A-BCD3 product update for PL IVN product TJA1051 in
diffusion fab ICN8

Date: October 2nd 2012

Table 1: Product Marking

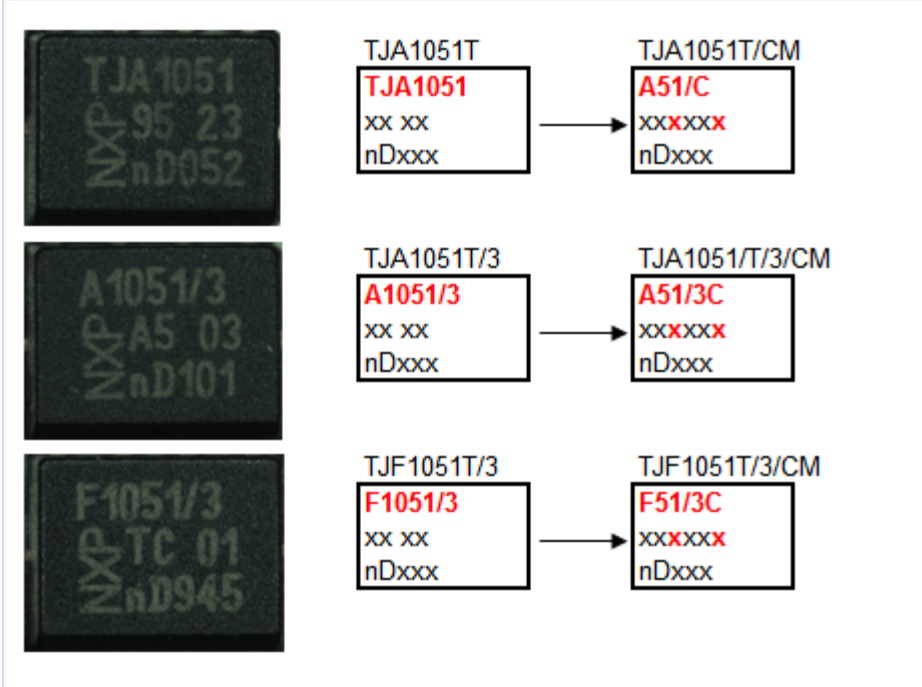
Marking of the TJA1051 product will be changed as follows:

n = assembly site APB, Thailand. The assembly site will not change.

In addition to the change in line B marking (6 characters i.s.o. 5 as explained above), there will be additional dashes between line B and C. The amount and position of these dashes can vary, see the 4 pictures below for examples. These are generic examples, all lines will follow above mentioned format.
